Model: Model-J P1c	Date: 4-Jun-02	No.: RG082001a
--------------------	----------------	----------------

RTB Correction

Subject: Machine Installation & Short Haul Transportation		Prepared by: H. Someya	
From: Technical Services sec. Service Planning Dept.			
Classification:	<input type="checkbox"/> Troubleshooting	<input type="checkbox"/> Part information	<input checked="" type="checkbox"/> Action required
	<input type="checkbox"/> Mechanical	<input type="checkbox"/> Electrical	<input type="checkbox"/> Service manual revision
	<input type="checkbox"/> Paper path	<input type="checkbox"/> Transmit/receive	<input type="checkbox"/> Retrofit information
	<input type="checkbox"/> Other ()

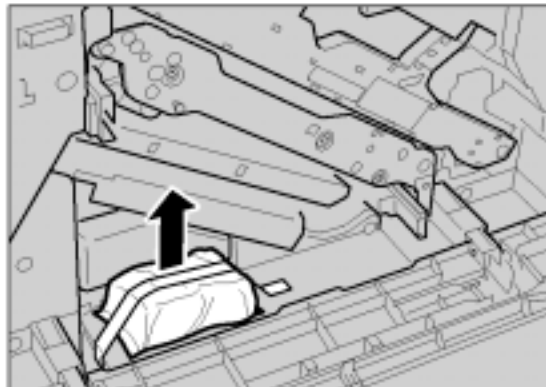
The transfer belt unit lever has been detached and placed inside the machine as shown in the illustration. This lever must then be reattached at installation by the customer or service technician.

1. Open the front cover.
2. Turn the transfer belt unit release lever counterclockwise to lower the transfer belt unit.
3. Remove the lever (1 screw).
4. Reinstall the lever when the machine arrives at the installation site.
